RE: Meeting with Summit Township Supervisors
Special Study
Kearsarge Pump Station

MTSA - KEARSARGE PUMP STATION
OVERFLOW RETENTION FACILITY (ORF)

Re: Kearsarge Pump Station Special Study-Draft
Review

COMMENTS & RESPONSES

FIGURE x-g

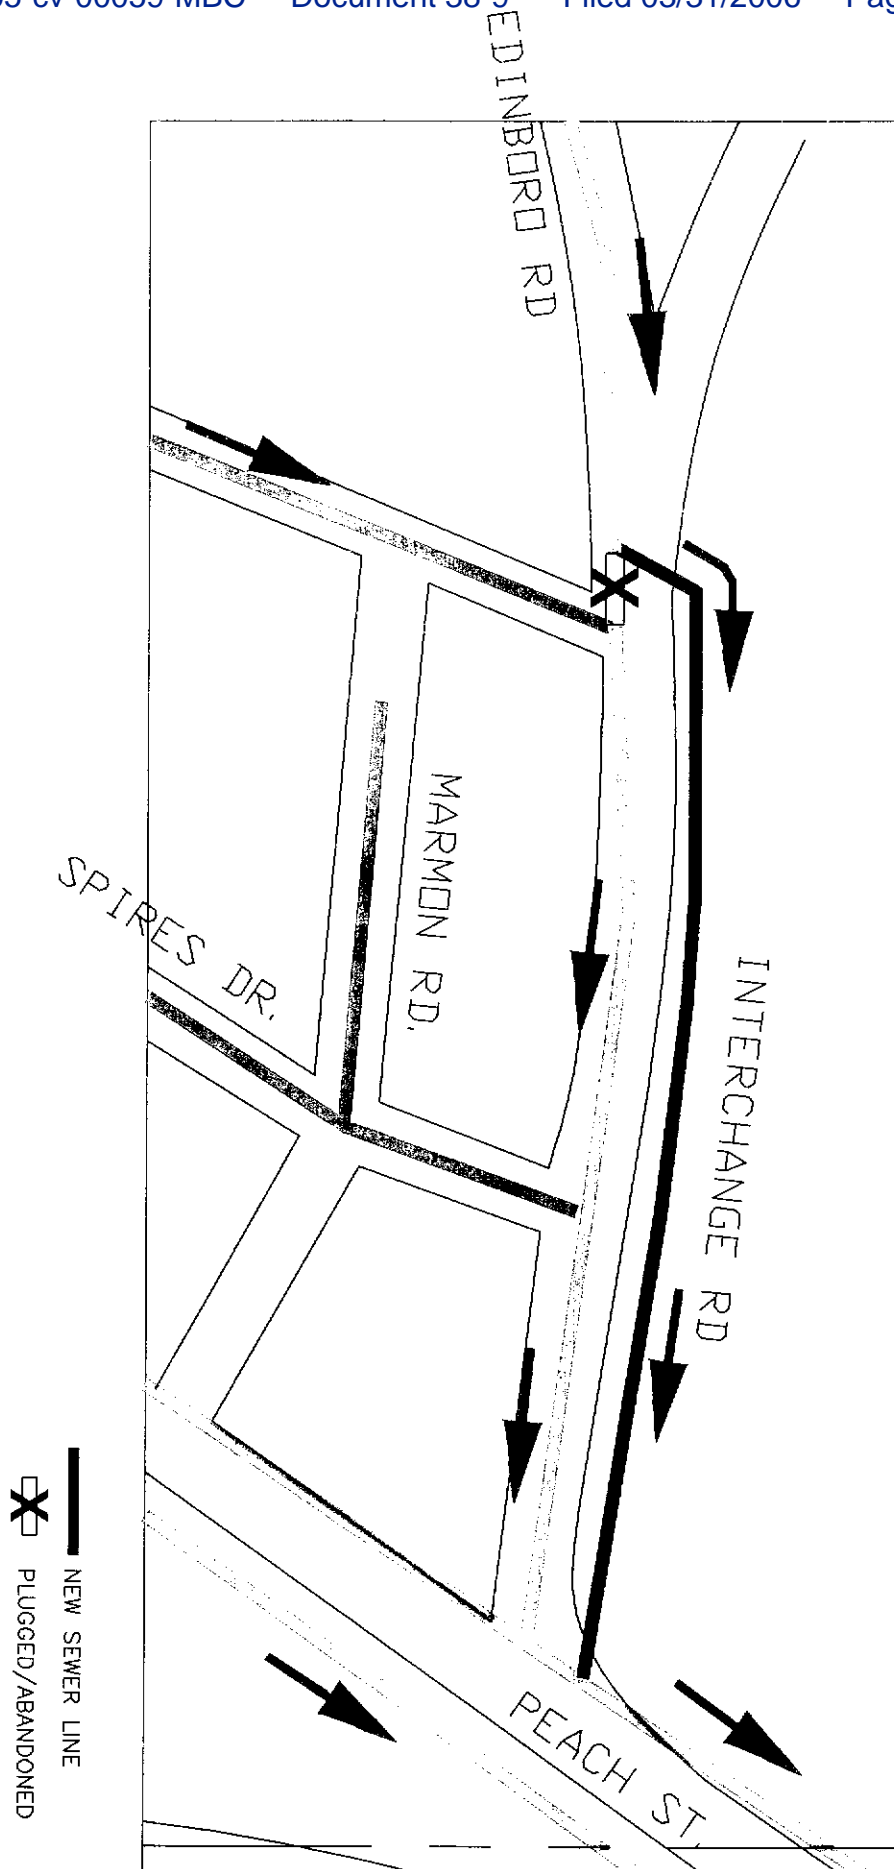
- 3) Figure I-a depicts the location of the proposed interceptor diversions. Without possessing knowledge of the locations of the existing sewer lines, this figure is difficult to interpret. Please modify, or provide an additional map that illustrates the direction of sewage flow before and after the proposed diversions.

- c. Better Description of Areas of Sewer Rehab and Proposed Changes?
Figure SI-a / VIII-d has been modified and Figures X-e, X-f, and X-g added to describe proposed changes.
- d. Study of Back Water Valve Needs Not Included?
Appendix volume included.
- e. Include Costs of Back Water Valves and Sewer Rehab?
Included in new Appendix A-4.
- f. Preface Storage Flow Wrong?
Changed.
- g. Summit Responses Concerning Study Recommendations?
Included in new Appendix A-1 and A-2.
- h. Address all items under 25 PA Code Section 71.31?
Yes
- i. Include Narrative on Removing Overflow without Spillage in Permit Application?
A suggested paragraph is included in new Appendix A-5.
